Re: Laborer's Union-Phase I, 10001 Bell Ave SE,

Grading and Drainage Plan

Engineer's Stamp dated 4/28/11 (L20/D043)

Based upon the information provided in your submittal received 3-24-11, the above referenced plan can not be approved for Building Permit and Grading Permit until the following comments are addressed.

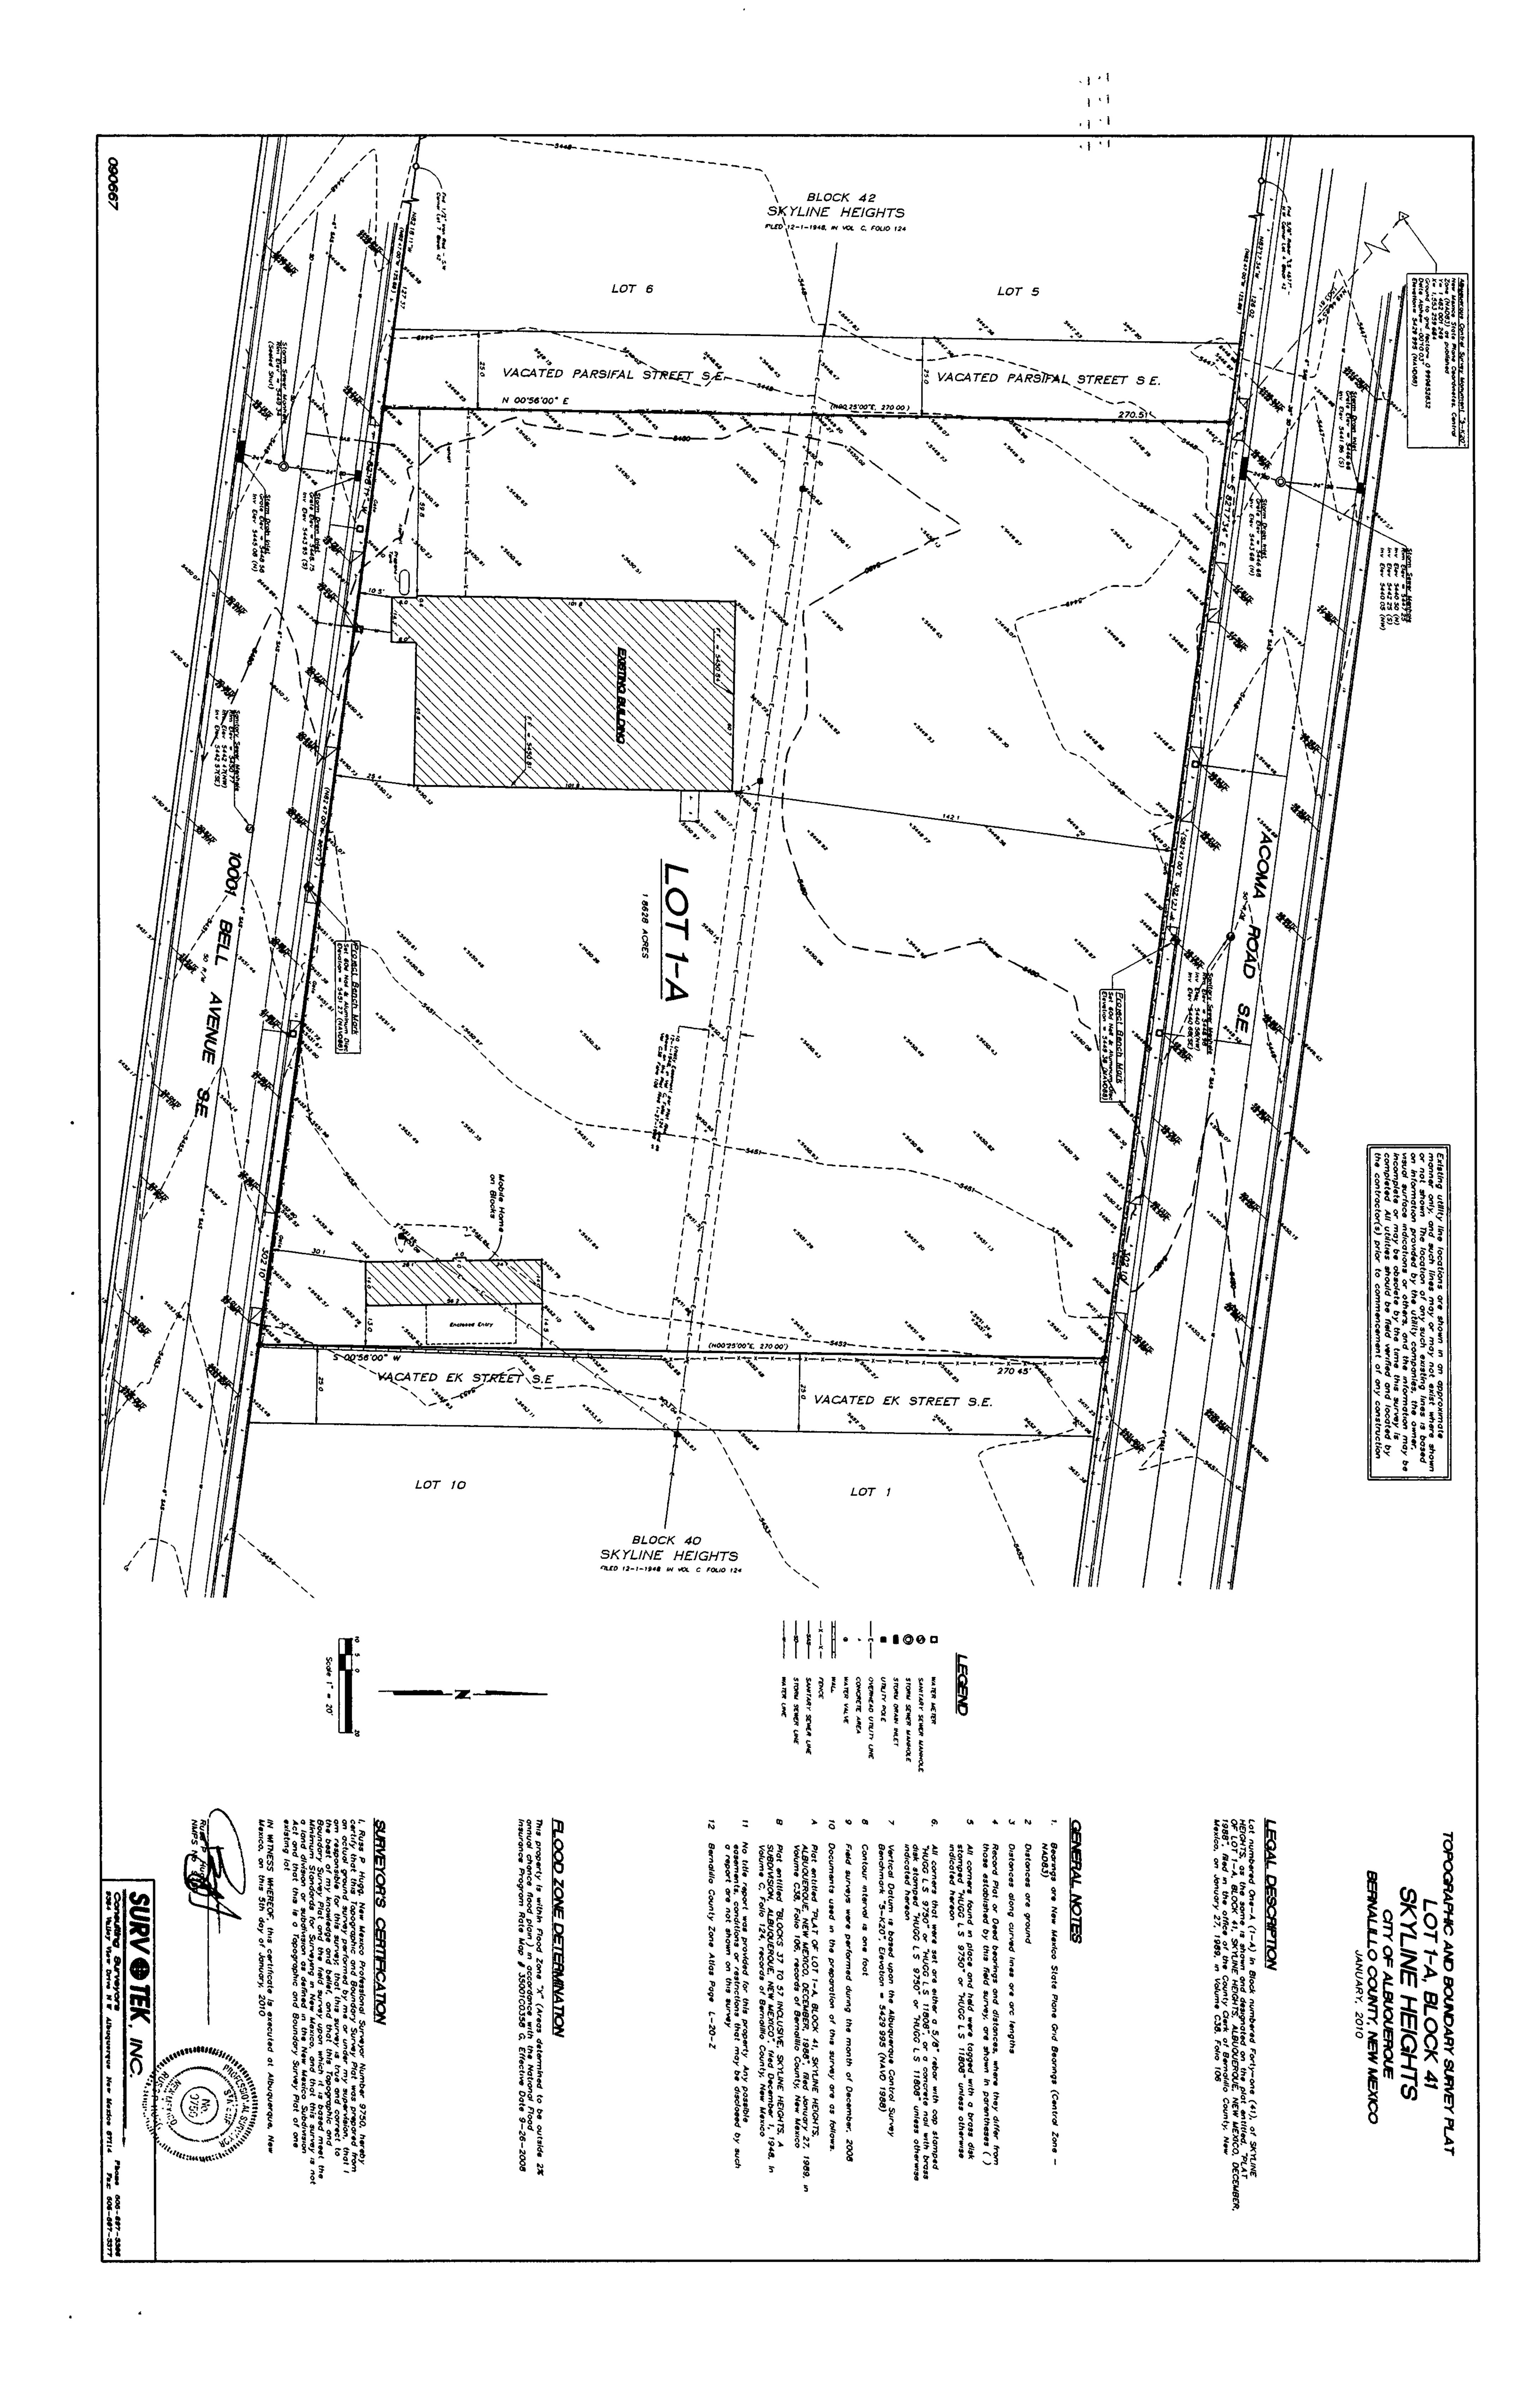
- 2. Are the contours according to the datum 29 or 88?

- 3. We would like to for all landscaped areas to be depressed. If at all possible, can the flows from the parking lots flow through the landscape areas before entering the streets. We revised the plans to include curb cuts and depressed landscape areas in the parking lot islands, as requested.

- 4. We are trying to avoid sidewalk culverts as much as possible. We would prefer for the flows to exit via the driveway in the Southwest corner of the lot or tie the 6" and 10" PVC into the back of the inlet on Bell Ave. or extend the PVC piping under the sidewalk.

Then contours shown reflect data from a topographic survey prepared by Russ P. Hugg (NMPS No. 9750) in January 2010 based upon the Albuquerque Control Survey Benchmark "5-K20", Elevation =5429.995 (NAVD 1988). We added a "Project Bench Mark" to the grading plan for reference during construction. Enclosed is a reduced copy of the ALTA for your use/file.

We revised the plans to connect the private area drain system into the existing storm inlet per City Standard Drawing No. 2237, as discussed during our meeting.
- 5. The 34ft 3" SCH40 at the north side of the building should not drain into the handicap parking.

We revised the location of the drain west of the ADA accessible parking space.
